United States Patent and Trademark Office

APPLICATION NO.	FILING DATE	FIRST NAMED INVENTOR	ATTORNEY DOCKET NO.	CONFIRMATION NO.
10/562,491	08/18/2006	Hans-Jurgen Hannig	LSP-8	8304
20311 1 11CAS & MF	7590 12/12/2007		EXAMINER	
LUCAS & MERCANTI, LLP 475 PARK AVENUE SOUTH			FONSECA, JESSIE T	
	15TH FLOOR NEW YORK, NY 10016			PAPER NUMBER
112 W 10144, 117 10010			3633	
			MAIL DATE	DELIVERY MODE
			12/12/2007	PAPER

Application No.	Applicant(s)				
•	10/562,491	HANNIG, HANS-JURGEN				
Office Action Summary	Examiner	Art Unit				
·	Jessie Fonseca	3633				
The MAILING DATE of this communication appears on the cover sheet with the correspondence address						
Period for Reply						
A SHORTENED STATUTORY PERIOD FOR REPLY WHICHEVER IS LONGER, FROM THE MAILING DA - Extensions of time may be available under the provisions of 37 CFR 1.13 after SIX (6) MONTHS from the mailing date of this communication. - If NO period for reply is specified above, the maximum statutory period w - Failure to reply within the set or extended period for reply will, by statute, Any reply received by the Office later than three months after the mailing earned patent term adjustment. See 37 CFR 1.704(b).	ATE OF THIS

Fig. 22: Palmberg (US 2003/0009971 A1)

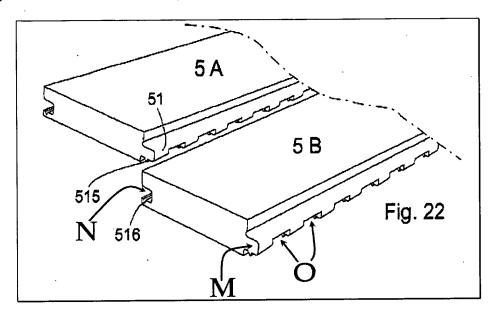
wherein mutually opposite edges of the panel (3A) have mutually complementary positively locking profiles (M, N) so that similar panels can be assembled, and wherein the surface of at least one of the positively locking profiles (N) has at least in regionwise manner raised portions (515) and recesses (O) (figs. 19 and 22), characterized in that the raised portions (515) is provided with an overdimension.

It is noted that the overdimension is capable be ground away by friction during assembly of two panels and that the recesses are of a volume in which resulting abrasion particles from the raised portions can be received.

With regards to claim 9: Palmber further discloses the positively locking profile (N) is in the form of a groove profile with an undercut configuration and the oppositely disposed positively locking profile (M) is in the form of a tongue profile with an undercut configuration (fig. 19- 22).

With regards to claim 10: Palmber further discloses the raised portions (515) and recesses (O) are provided on the tongue profile (M) and the groove profile (N) has a smooth surface (figs. 21- 22). The smooth surface of the grooved

With regards to claim 11: Palmber further discloses the raised portions (515) and recesses (O) are arranged at a tongue (M) underside which is capable of facing towards a laying surface.
